THIRD FLOOR

BEDROOM 3/
DRESSING ROOM
(EXISTING BOARDING)

1435 - P127

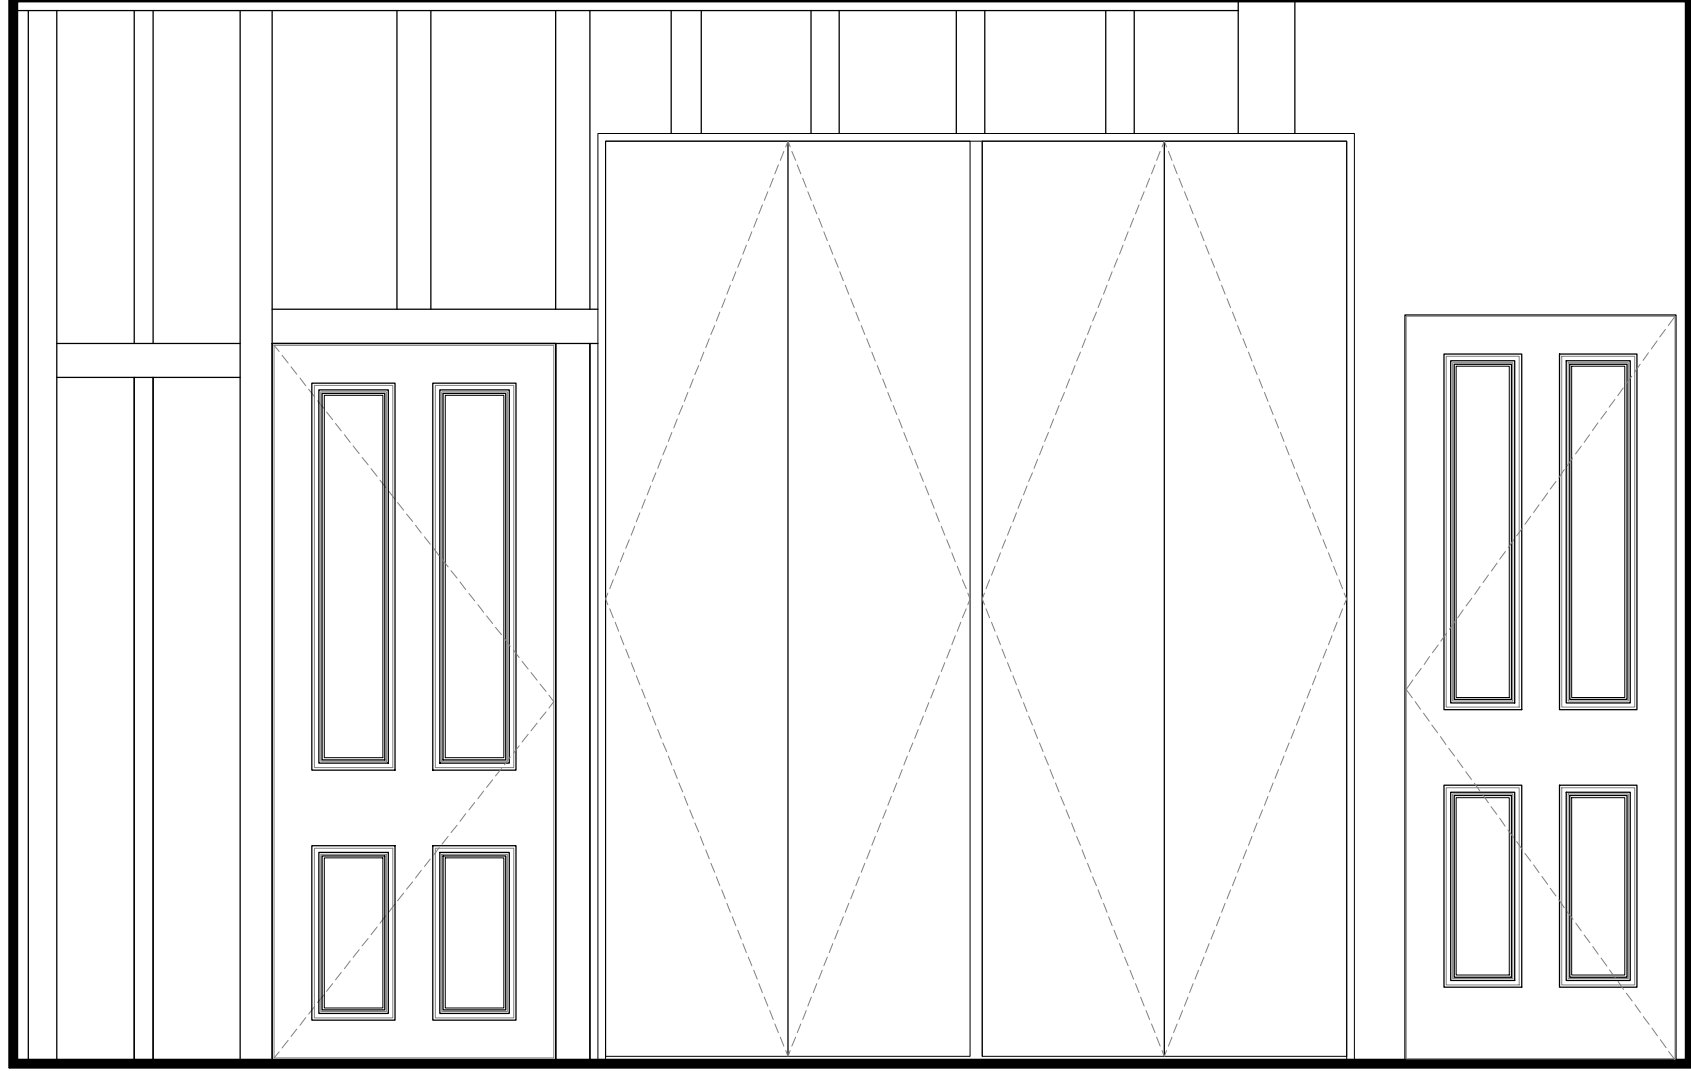
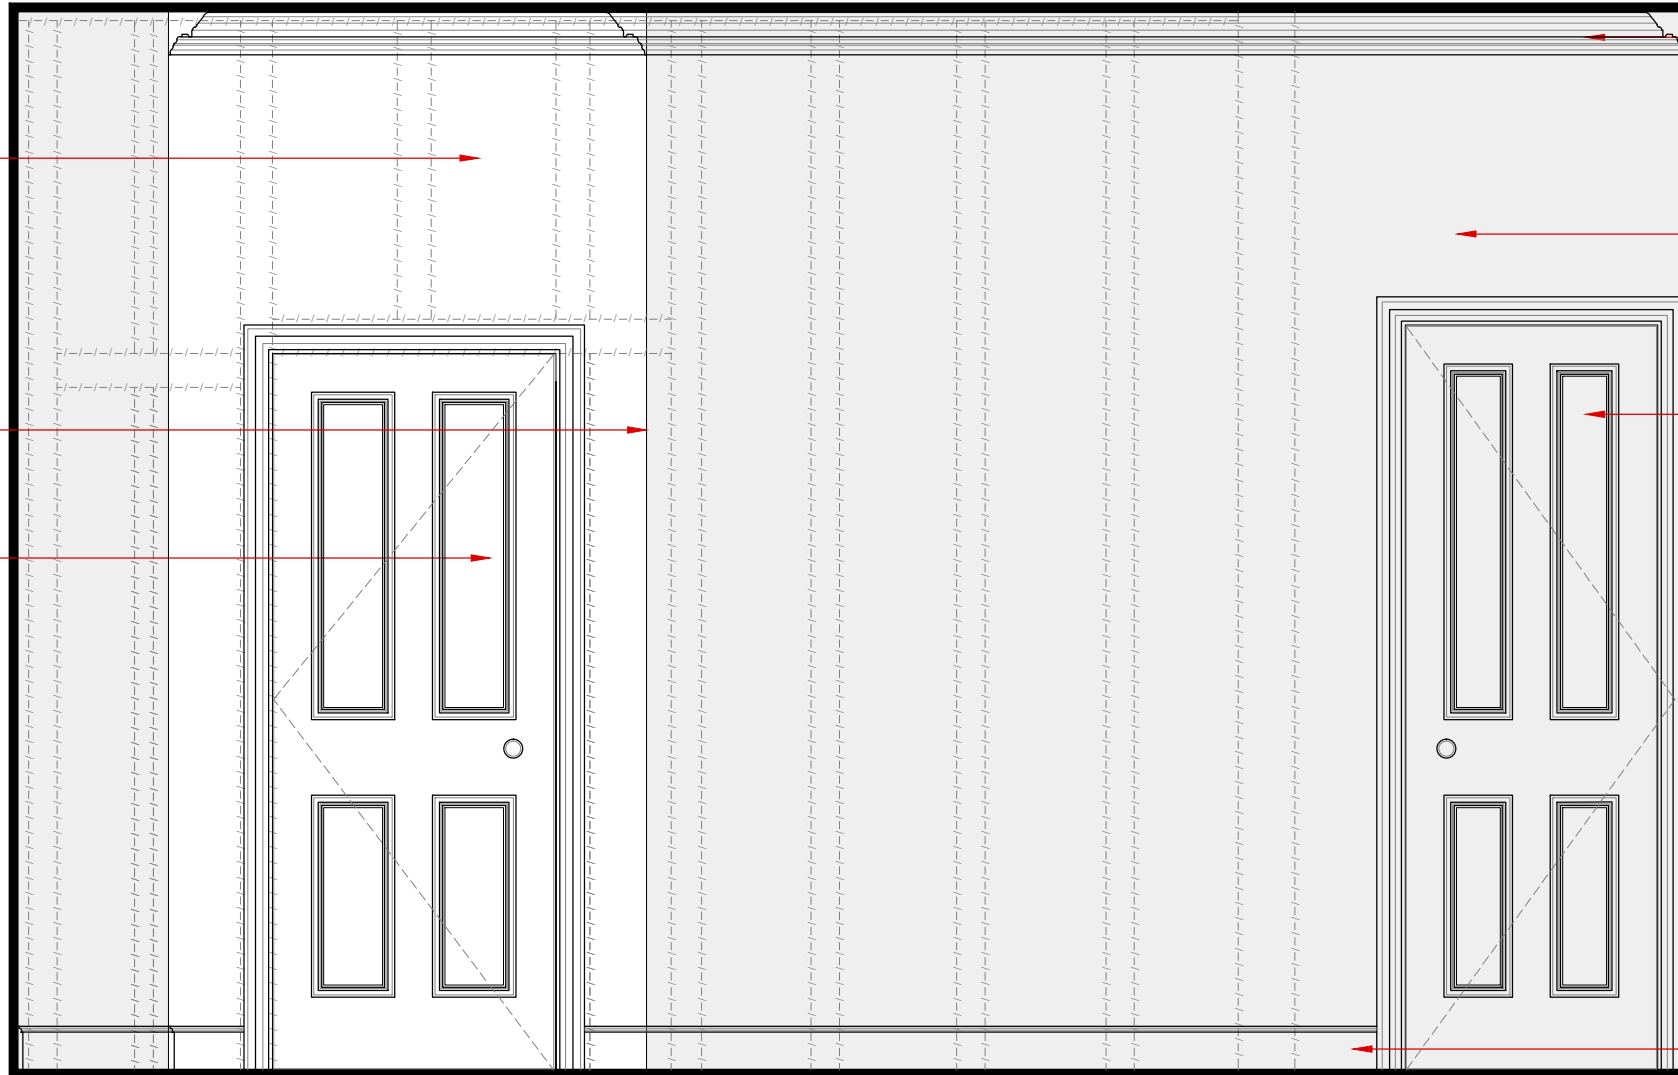
Rev	Date	Notes
A	14.05.15	Notes revised following comments from council.
B	23.06.15	Room name changed and joinery added

Existing non-original exposed stud work wall to be clad with plasterboard.

Proposed door to remain in current location and to match existing.

New cornice to room to match existing within master bedroom.

Existing doorway to remain. Door to be fixed closed.

Existing skirting to be replaced to match Bedroom 3.

1435 - P128

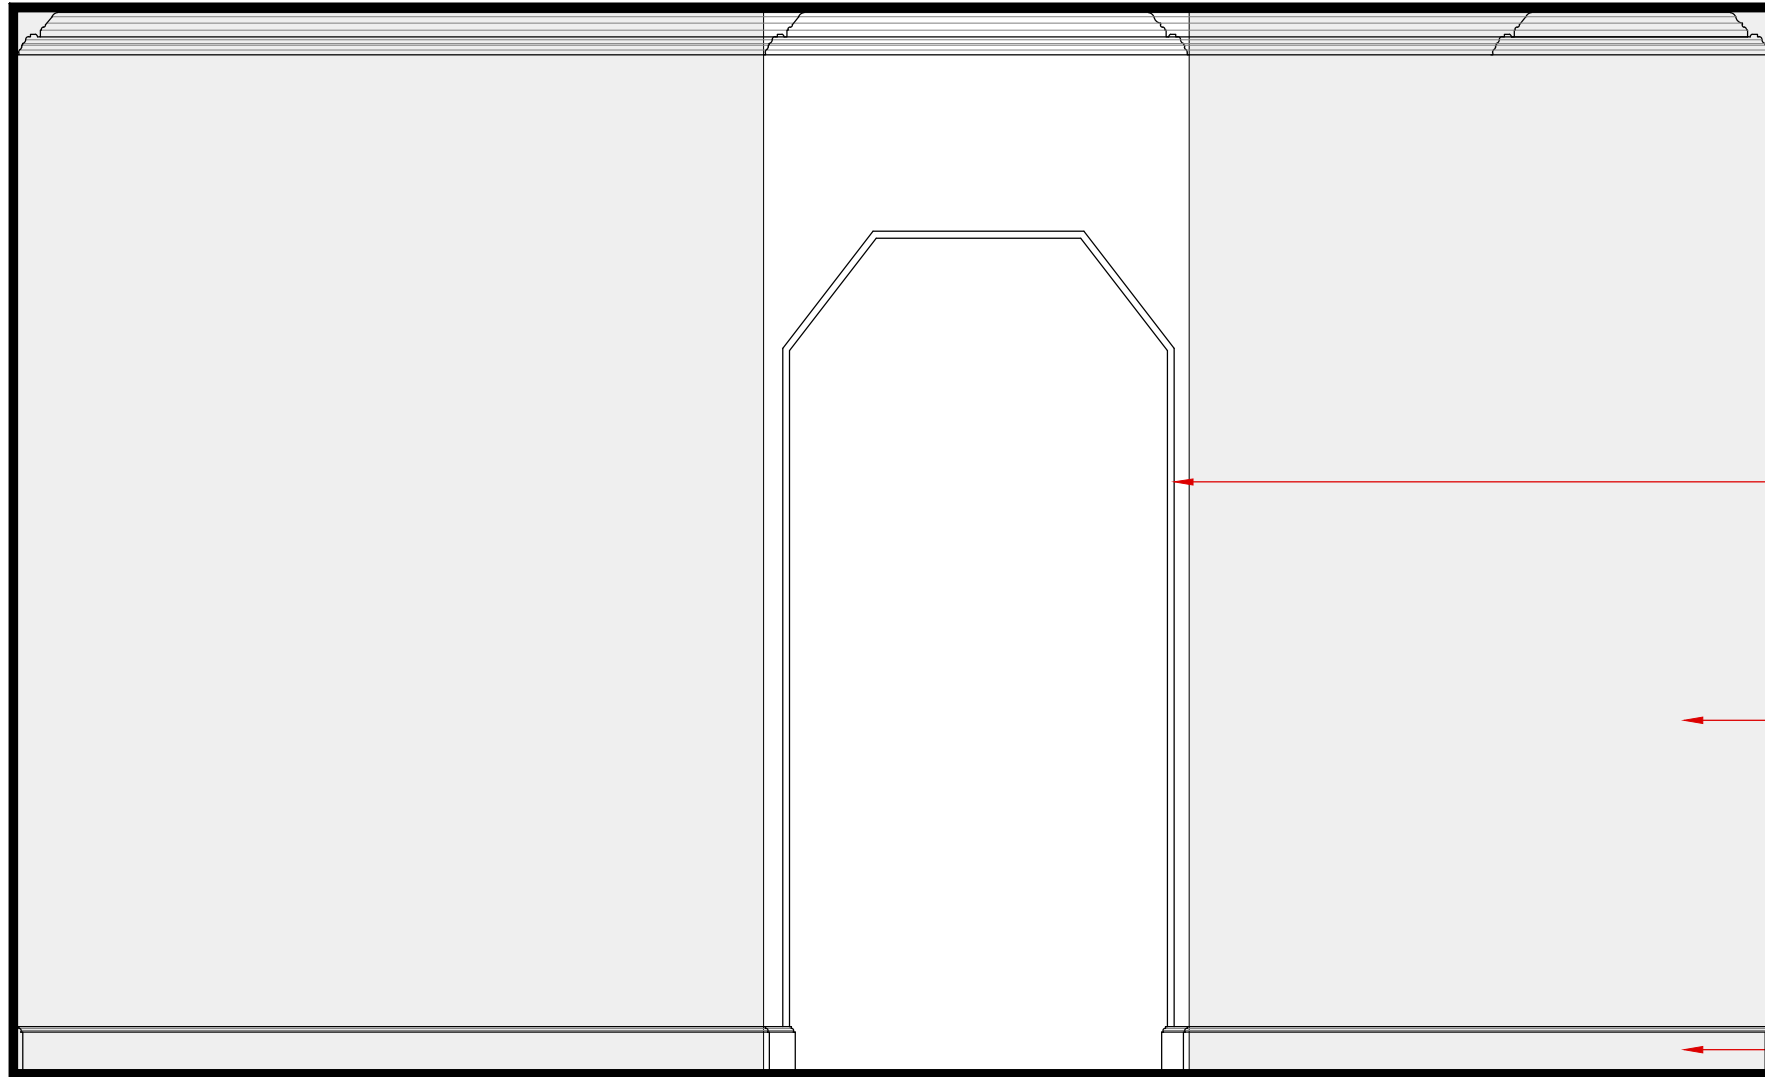
Rev	Date	Notes
A	23.06.15	Room named changed joinery and opening added.

Proposed opening
between dressing
rooms.

Proposed joinery

Existing skirting to be
replaced to match
Bedroom 3.

1435 - P129

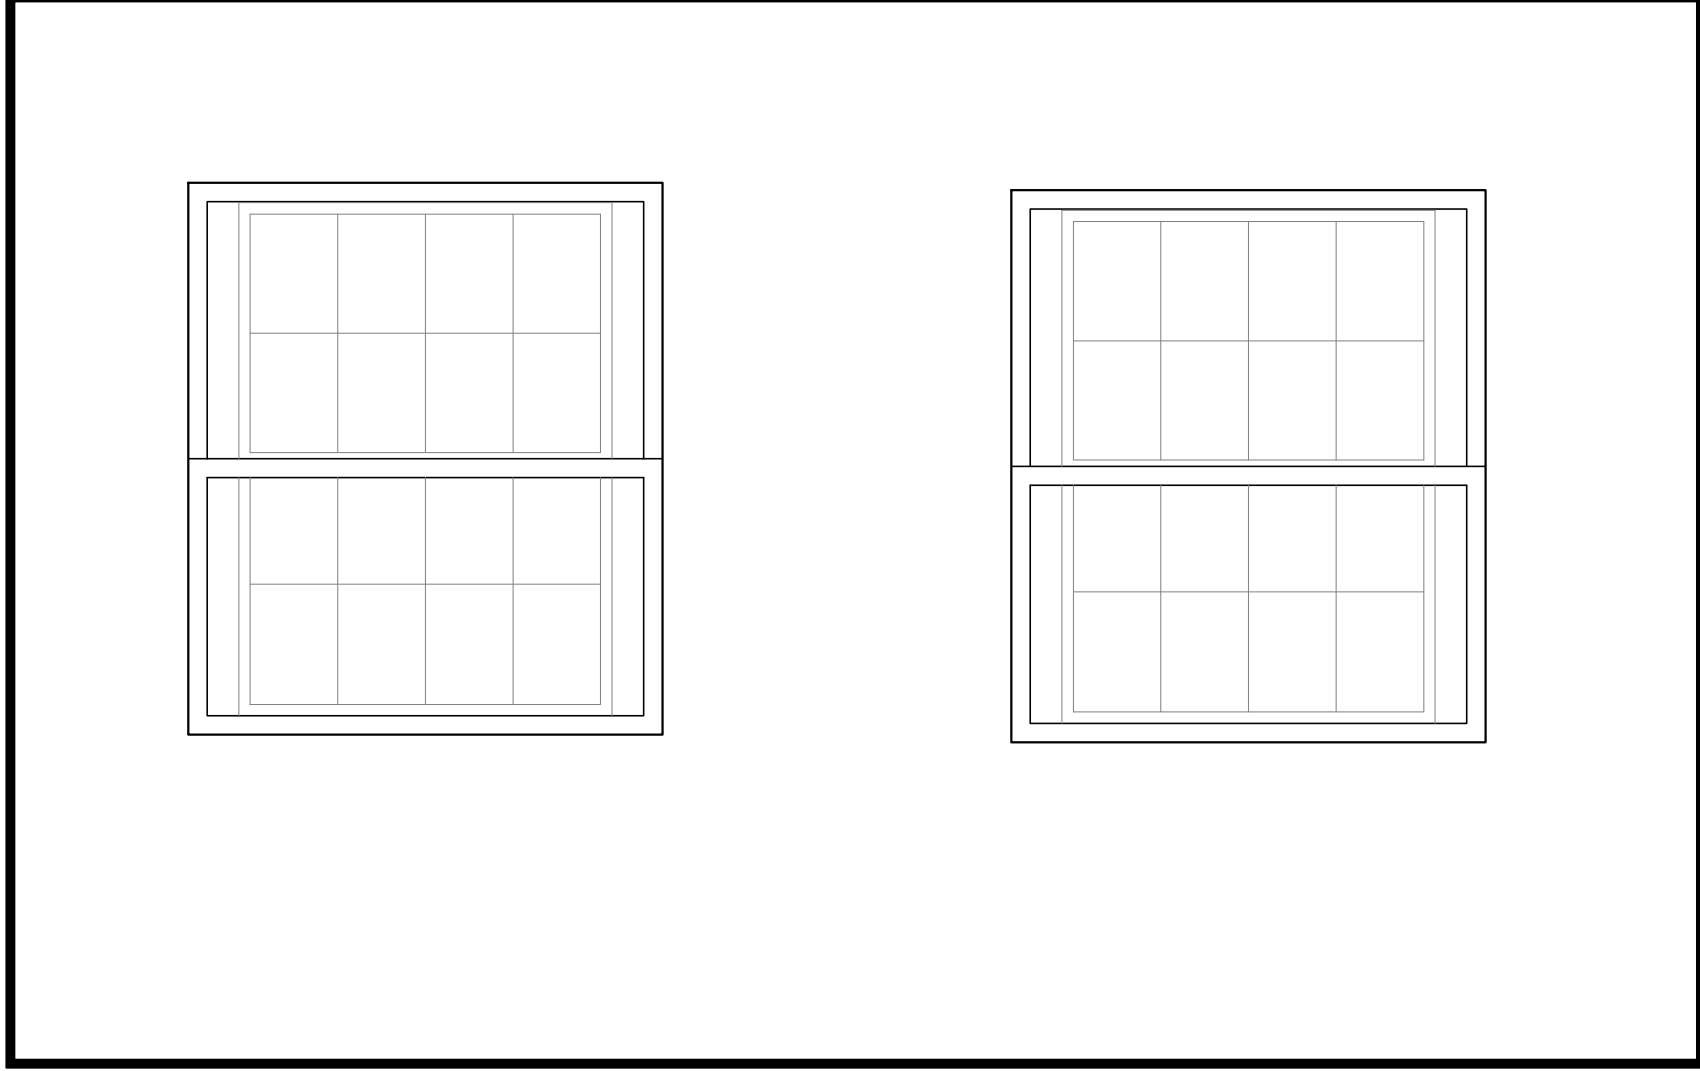
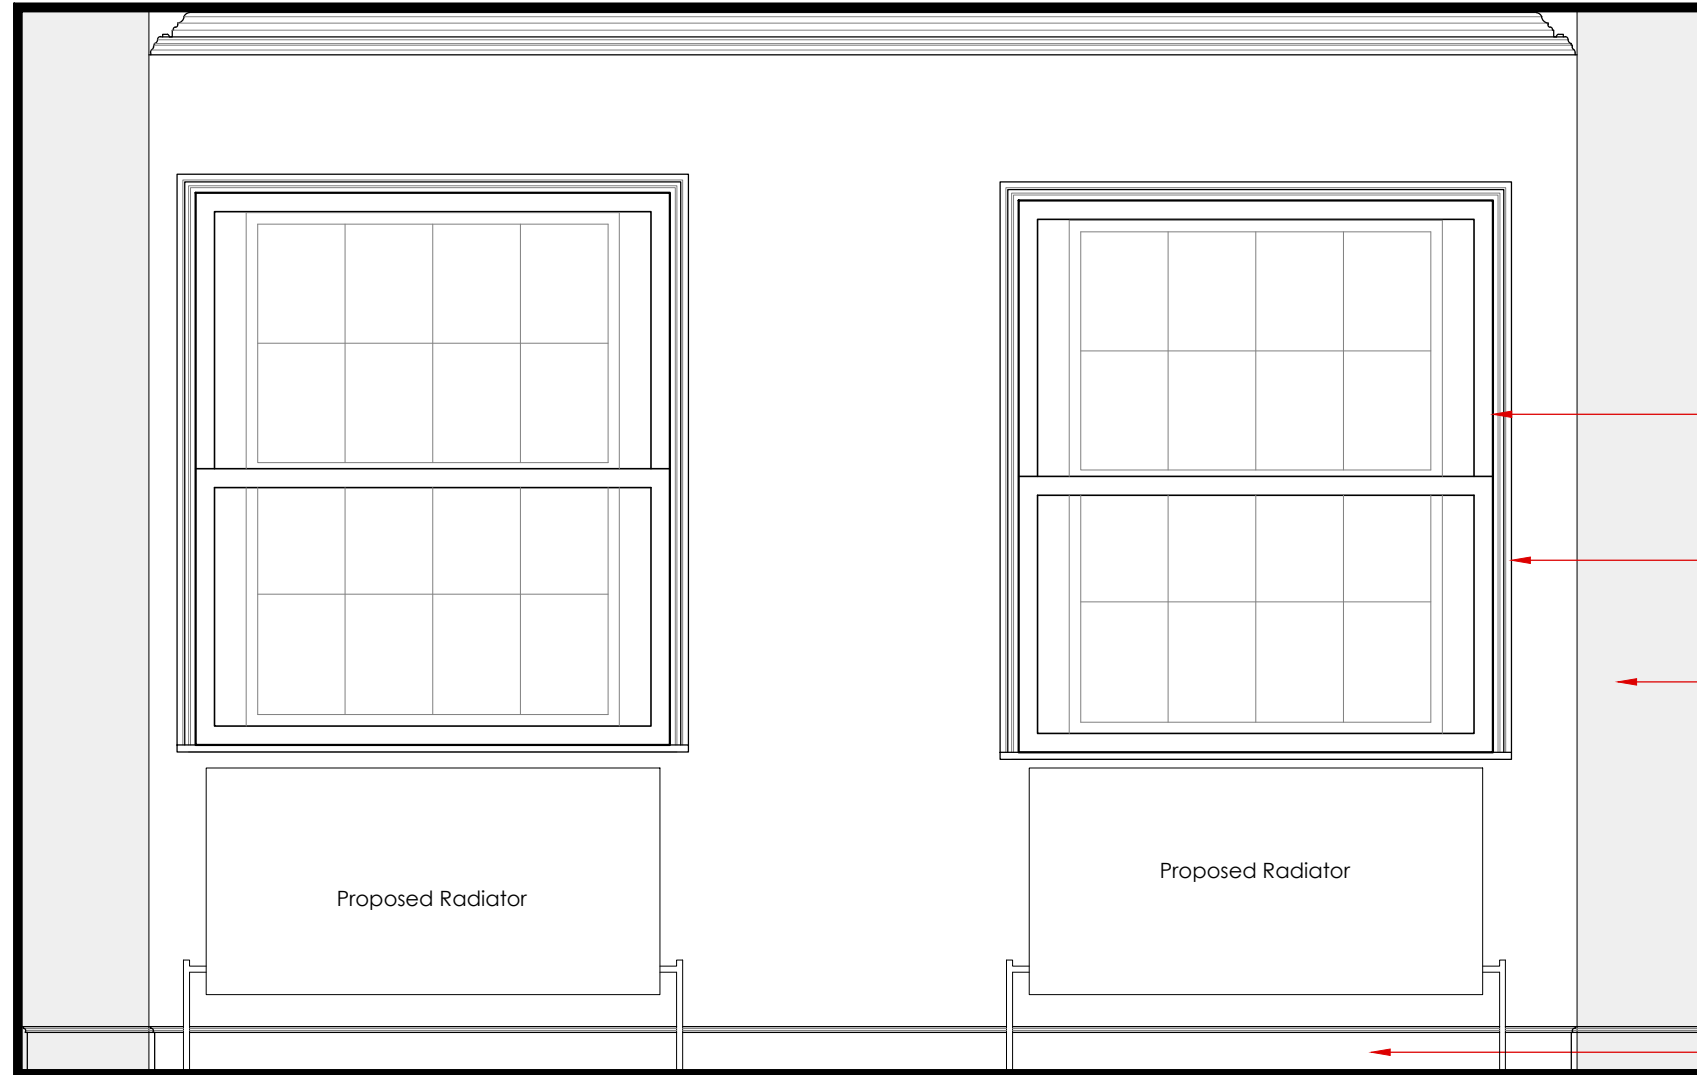
Rev	Date	Notes
A	23.06.15	Room named changed joinery revised and radiators added.

Existing secondary glazing to be removed and replaced with new.

Proposed 50mm architrave to surround of window.

Proposed joinery.

Existing skirting to be replaced to match Bedroom 3.

Proposed Radiator

Proposed Radiator
